RESOLUTION MSC.38(63)
(adopted on 19 May 1994)
ADOPTION OF AMENDMENTS TO THE CODE FOR THE CONSTRUCTION AND EQUIPMENT
OF MOBILE OFFSHORE DRILLING UNITS, 1989

MSC 63/23/Add.1

AMENDMENTS TO THE CODE FOR THE CONSTRUCTION AND EQUIPMENT
OF MOBILE OFFSHORE DRILLING UNITS, 1989, TO INTRODUCE
REFERENCE TO GUIDELINES FOR VESSELS WITH
DYNAMIC POSITIONING SYSTEMS

AMENDMENTS TO THE CODE FOR THE CONSTRUCTION AND EQUIPMENT
OF MOBILE OFFSHORE DRILLING UNITS, 1989, ON PROVISIONS
FOR HELICOPTER FACILITIES

Figure 13-1 - Helideck obstacle limitation sector

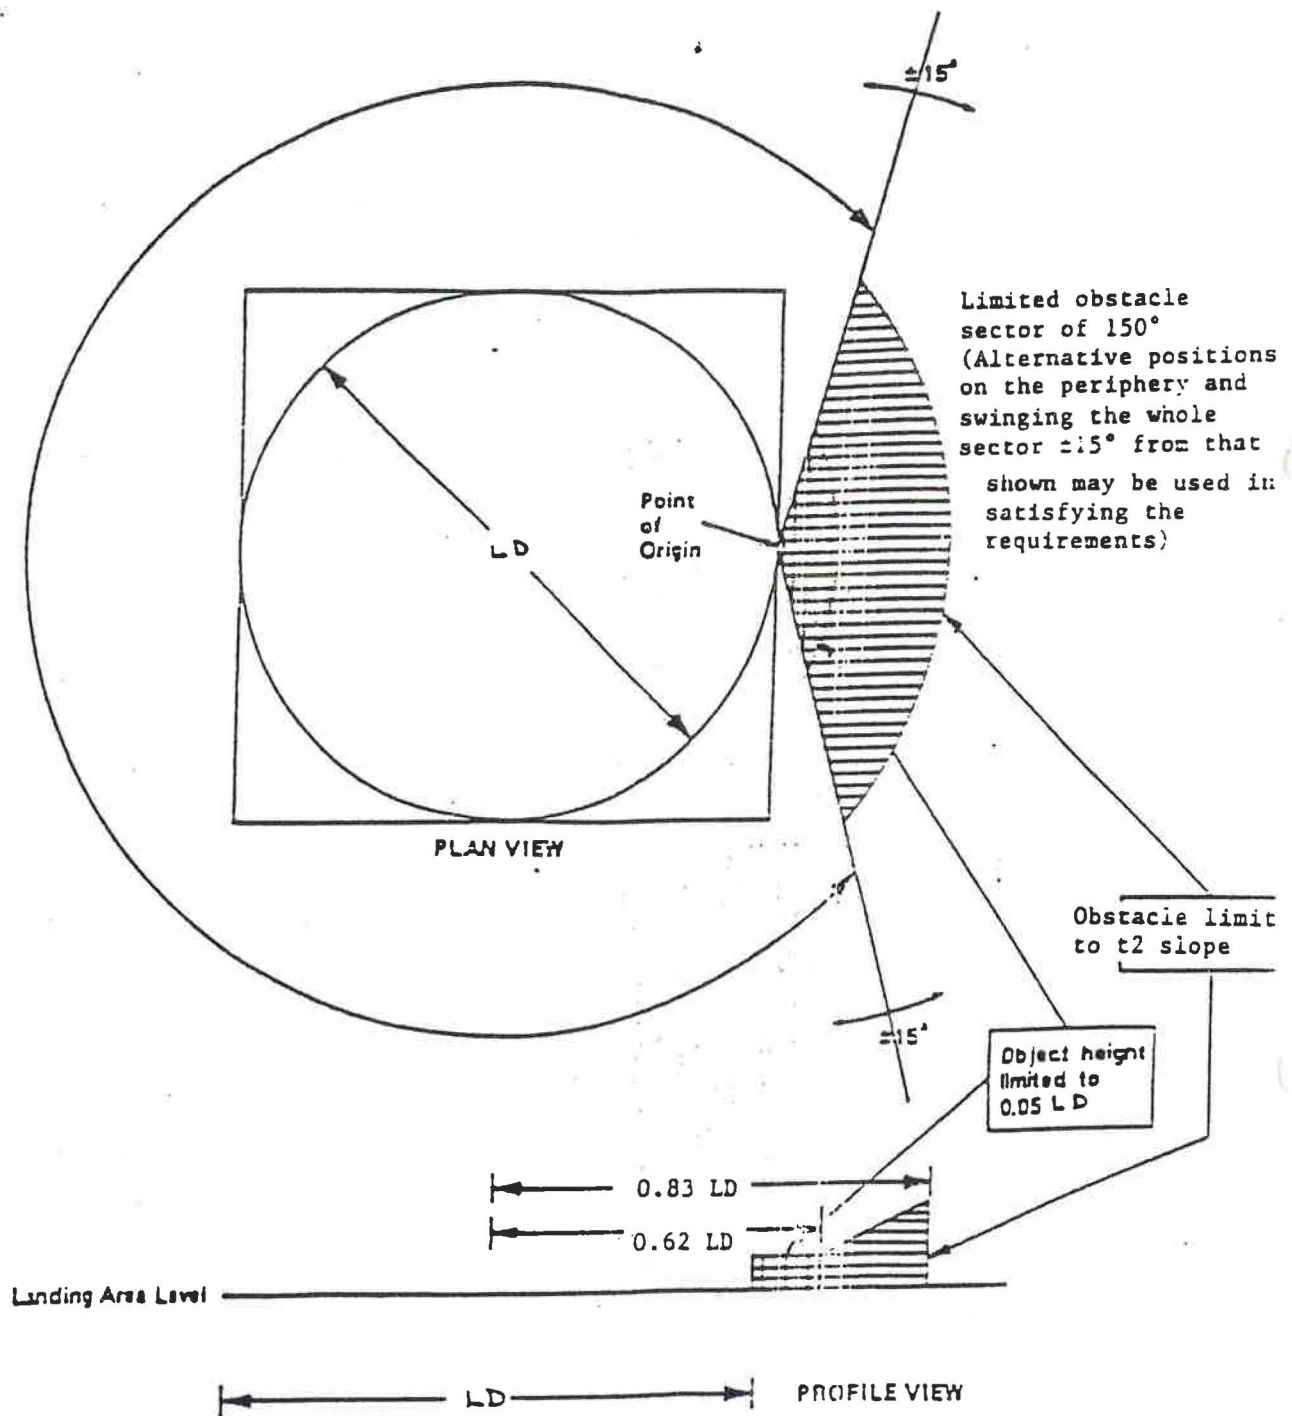
- .3 The obstacle-free sector should be not less than 210°.
- .4 For single main rotor and side by side twin main rotor helicopters, within the 150° limited obstacle sector out to a distance of 0.62 LD, measured from the centre of the helideck, objects should not exceed a height of 0.05 LD above the helideck. Beyond that arc, out to an overall distance of 0.83 LD, the limited obstacle sector rises at a rate of one unit vertically for each two units horizontally (see figure 13-1).

Figure 13-2 - Helideck obstacle limitation sector

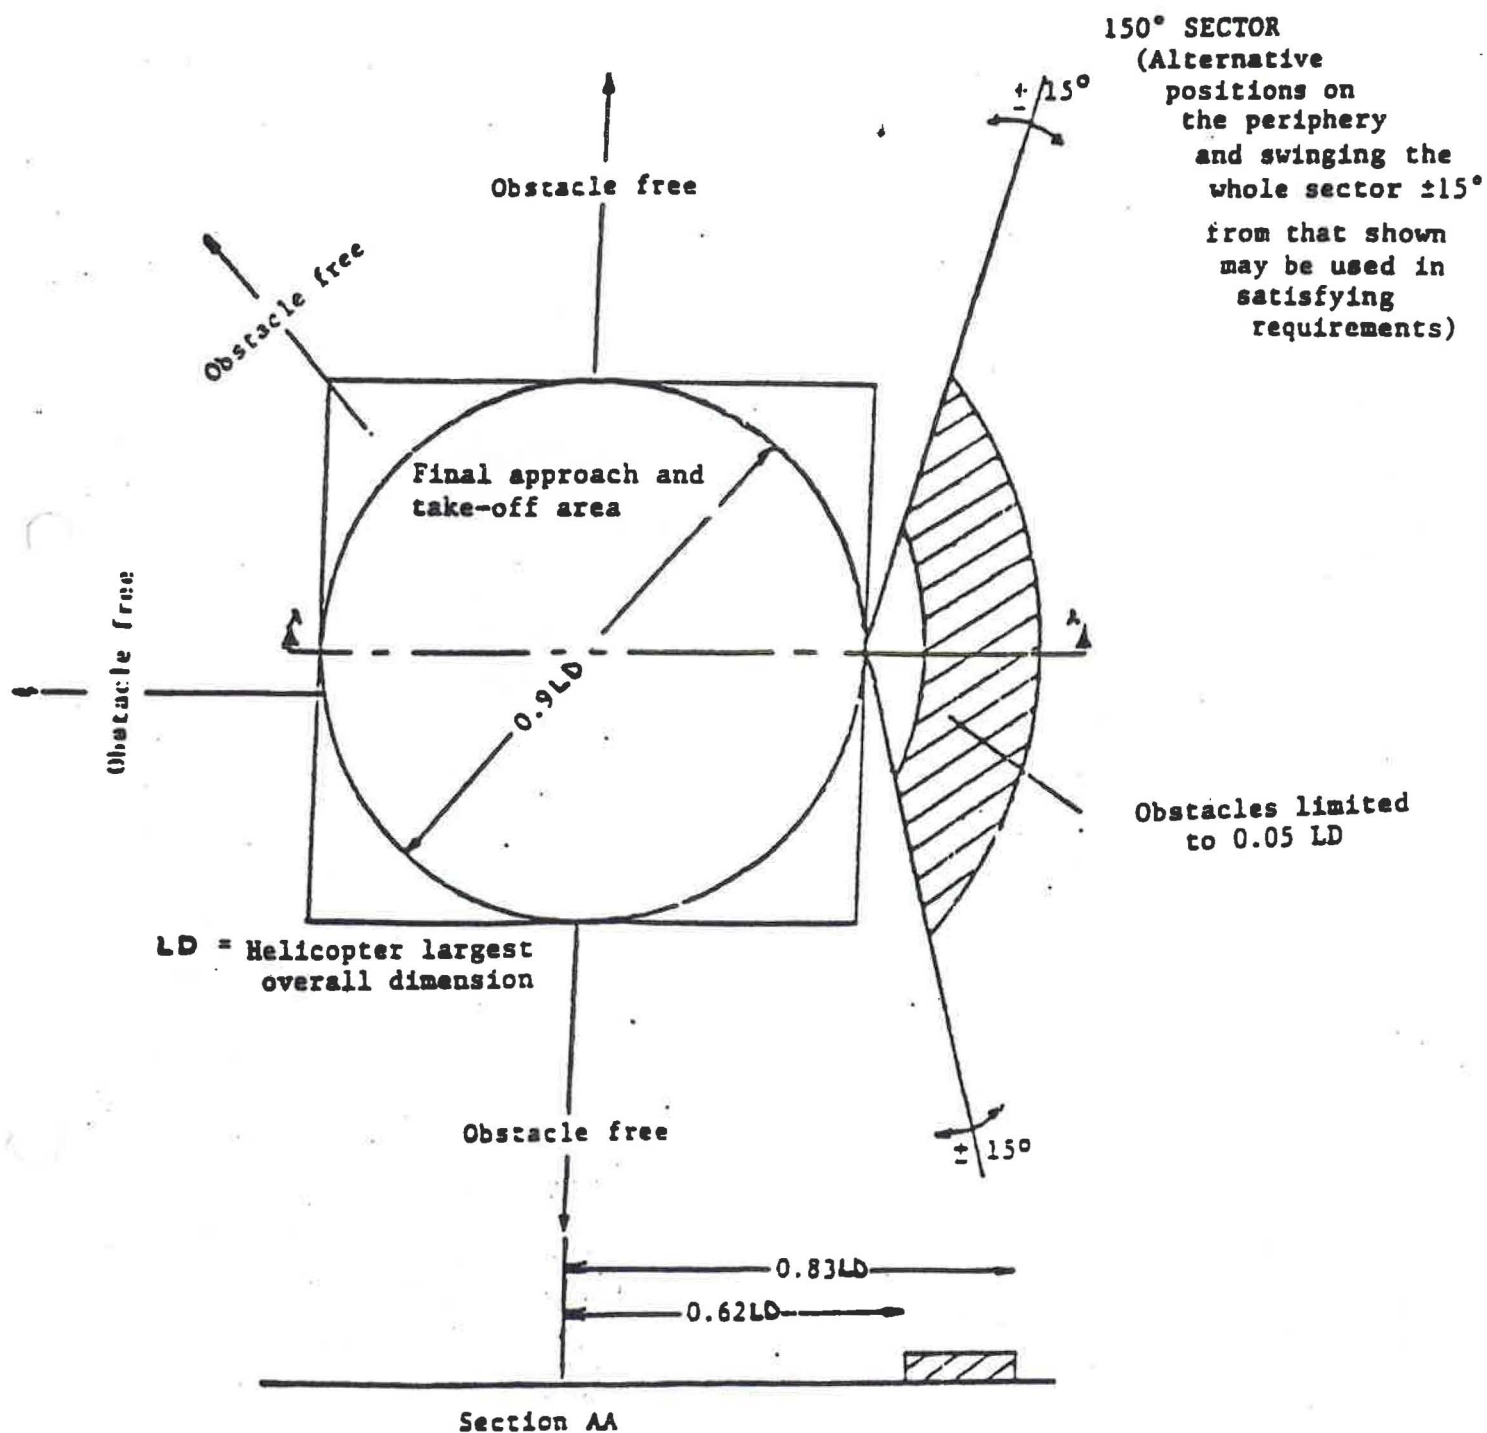
- .5 For omnidirectional operations by tandem main rotor helicopters, within the 150° limited obstacle-free sector out to a distance of 0.62 LD, measured from the center of the helideck, no fixed obstacles should be allowed. Beyond that arc, out to an overall distance of 0.83 LD, the obstacle height is limited to 0.05 LD (see figure 13-2).

Figure 13-3 - Helideck obstacle limitation sector

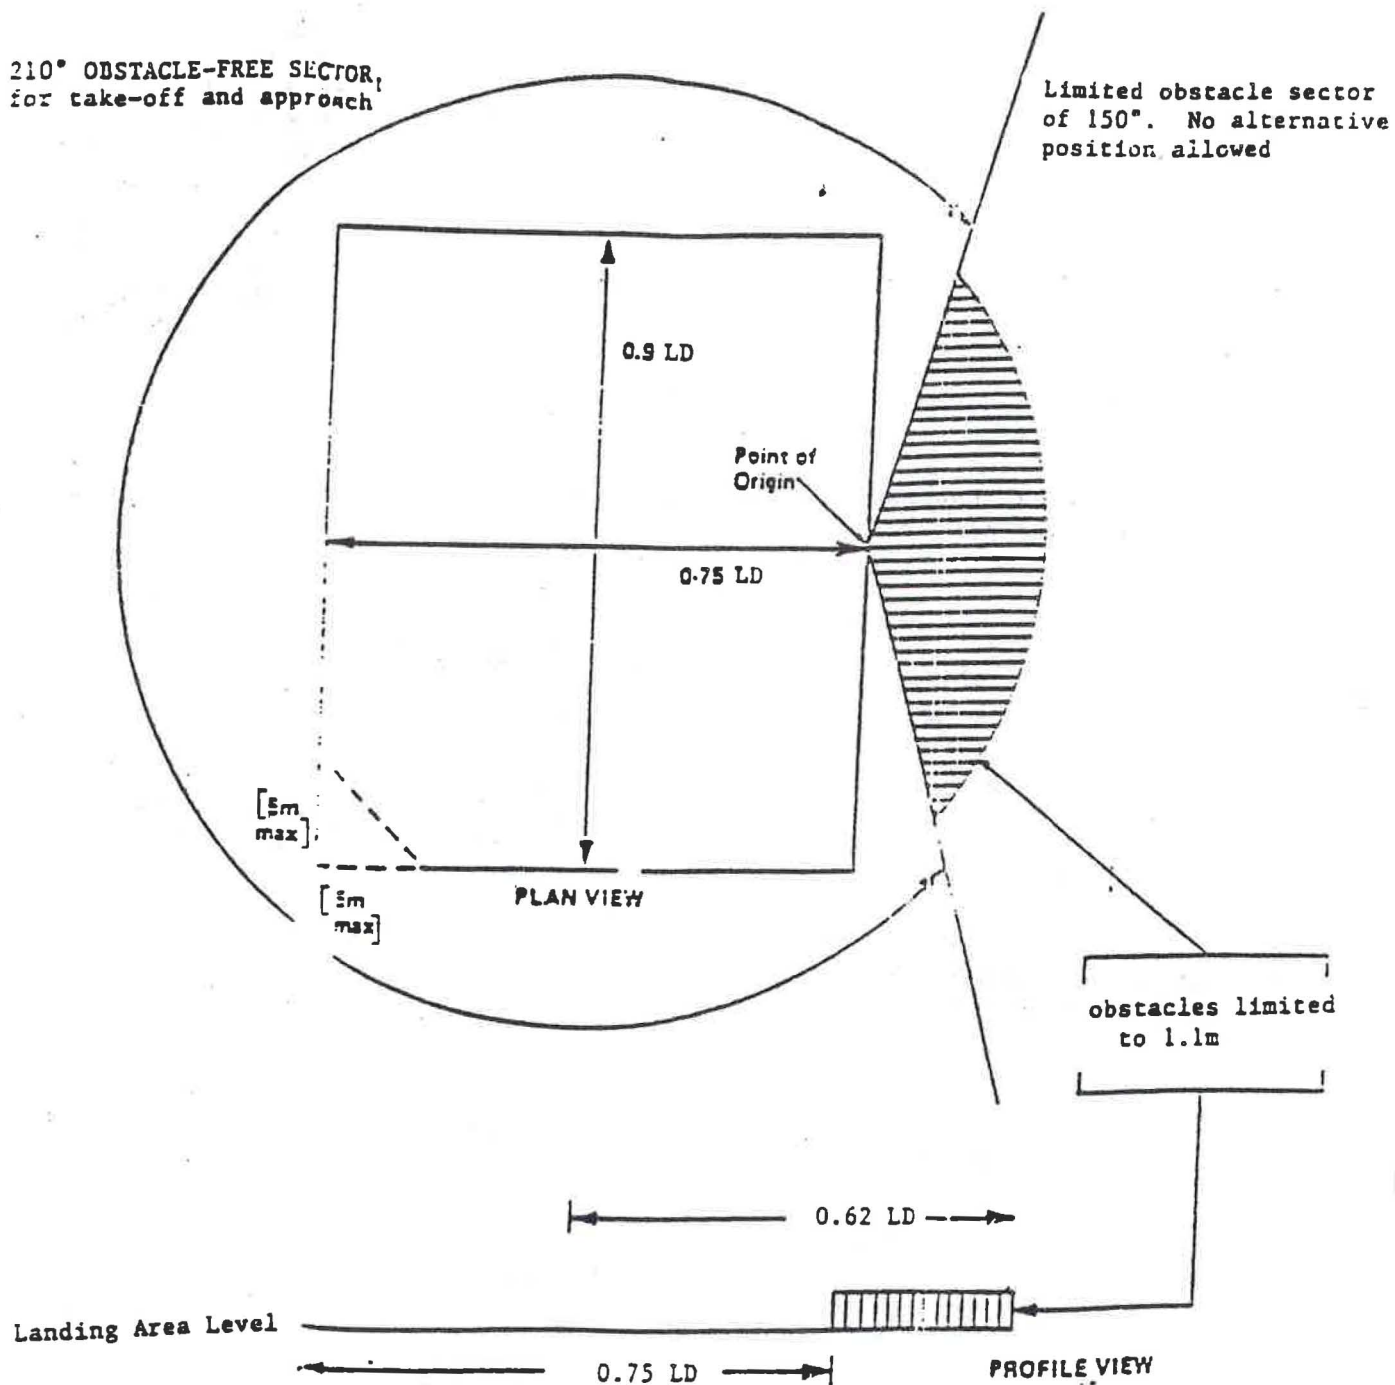
- .6 For bidirectional operations by tandem main rotor helicopters, within the 0.62 LD arc in the 150° limited obstacle-free sector, objects should not penetrate a level surface which has a height equivalent to 1.1 m above the helideck (see figure 13-3).

Figure 13-4 - Helideck obstacle limitation sector

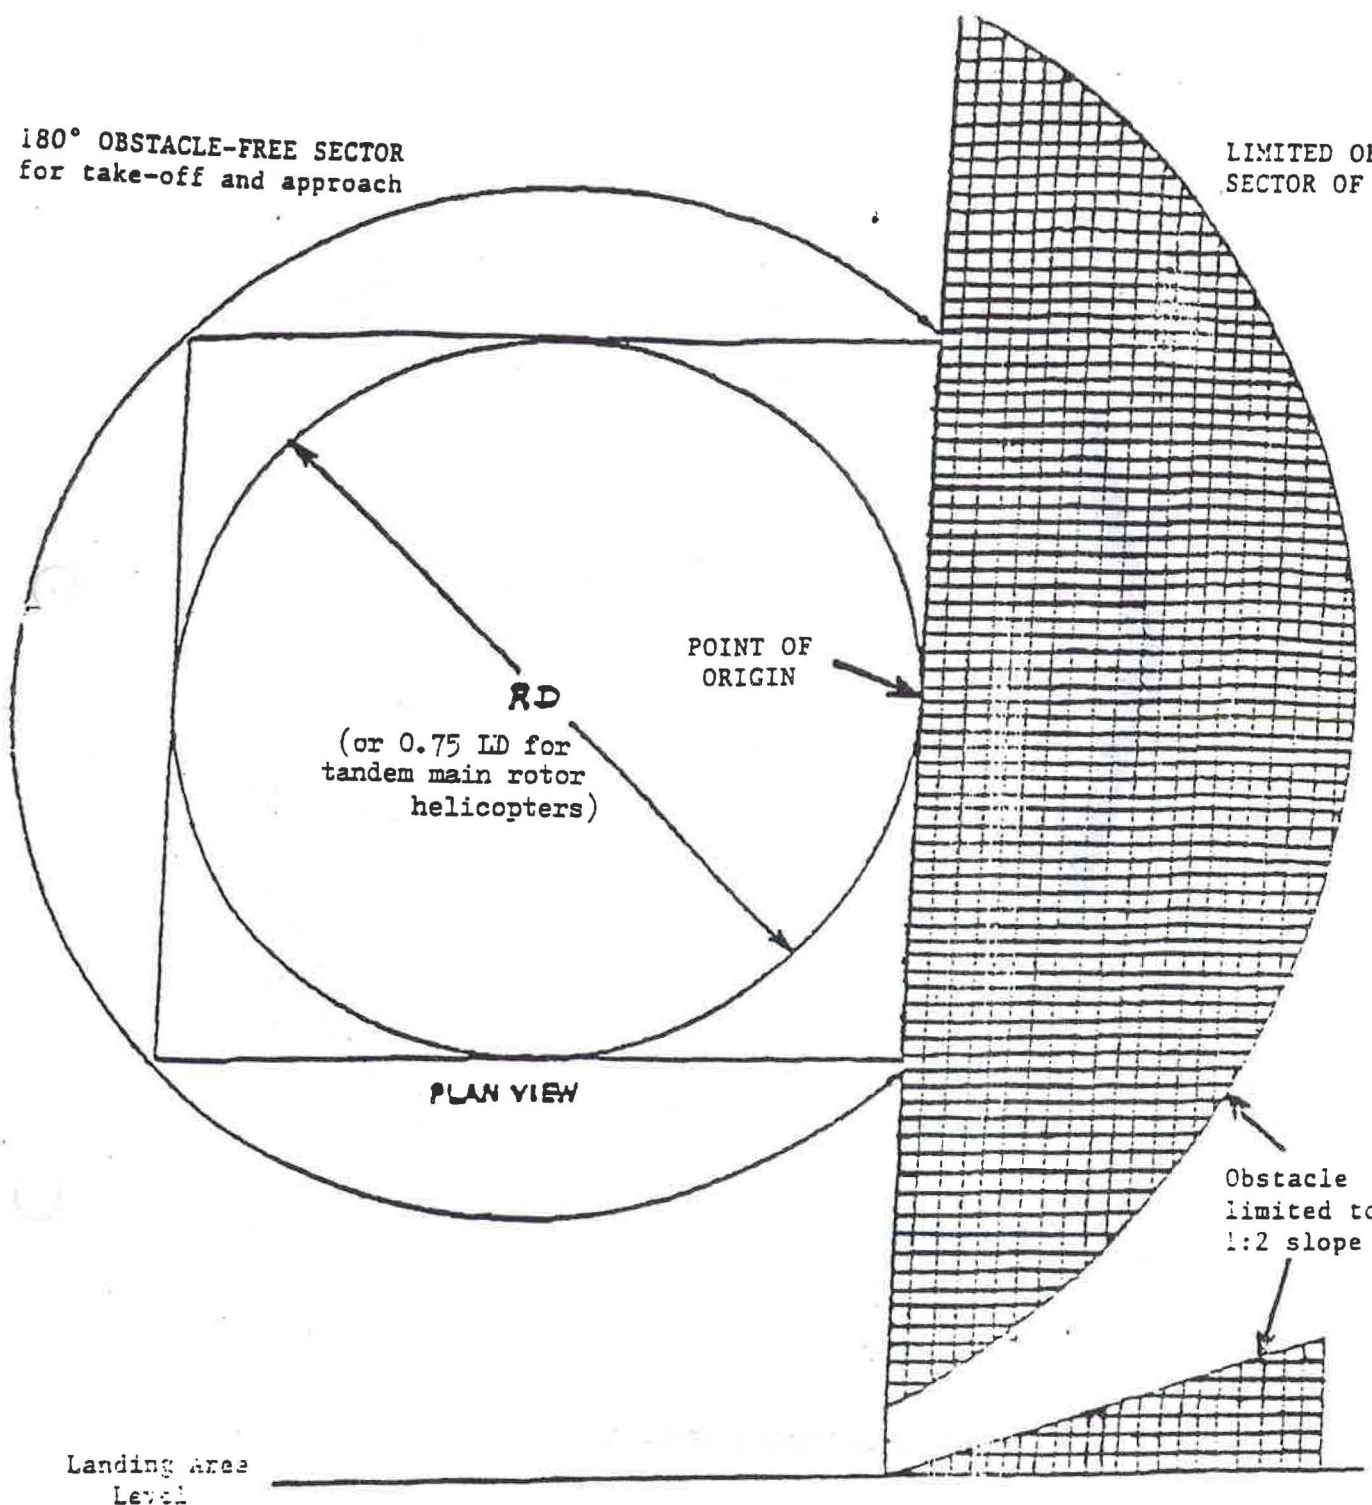
- .1 The helideck should be of sufficient size to contain a circle of diameter equal to RD. In the case of MODUs expected to be routinely serviced by tandem main rotor helicopters, the helideck should be of sufficient size to contain a circle of diameter equal to at least 0.75 LD.
- .2 The helicopter deck should have an obstacle-free sector of at least 180° free of obstructions. The reference point for this sector should be a point on the periphery of the circle referenced in paragraph 13.3.3.1, as shown in figure (13-4).

- .3 The limited obstacle sector should extend out to a distance of 0.83 RD for general operating areas. This distance should be measured from the centre of the helicopter deck. Obstructions in the limited obstacle sector should not extend above a plane measured vertically from the edge of the deck with rise at a rate not exceeding one unit vertically for each two units horizontally from the edge of the helideck (see figure 13-4).

Figure 13-5 - Obstacle-free sector marking

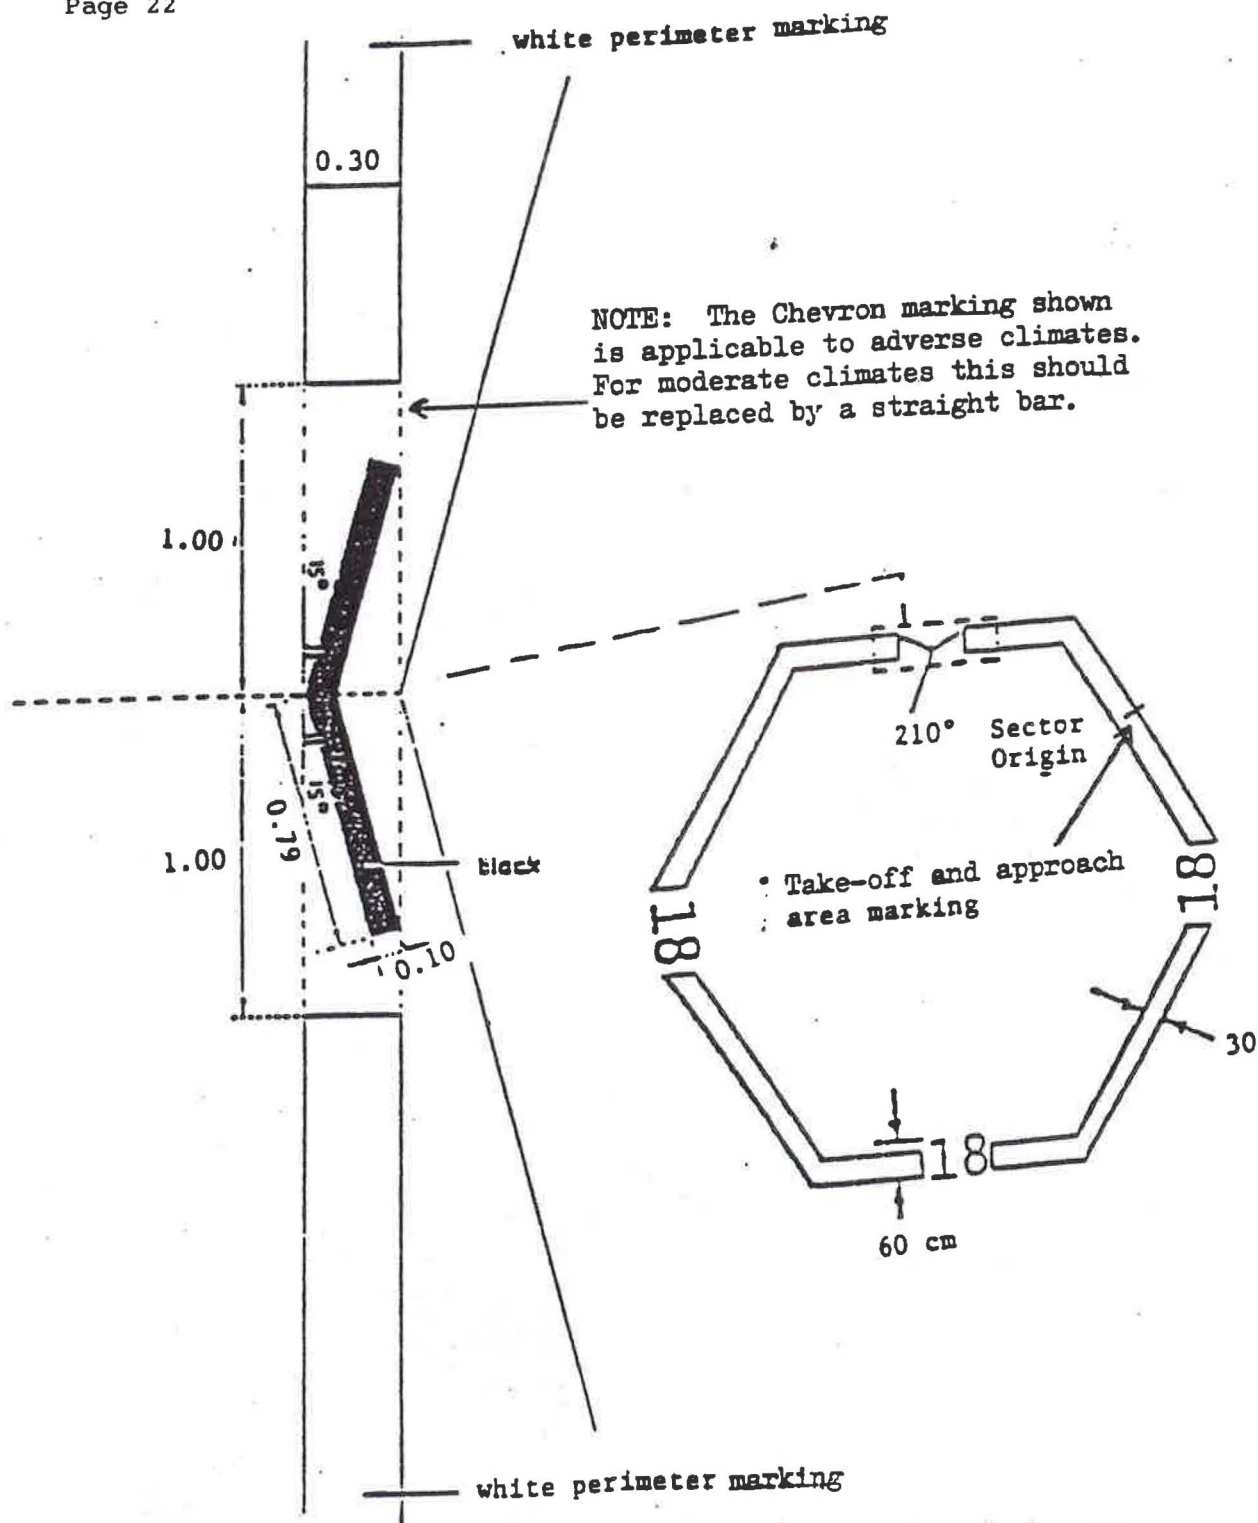
- .5 the helideck obstacle-free sector marking should indicate the origin of the obstacle-free sector, the direction of the limits of the sector and the design dimensions (the LD or RD value) of the helideck, as shown in figure 13-5.
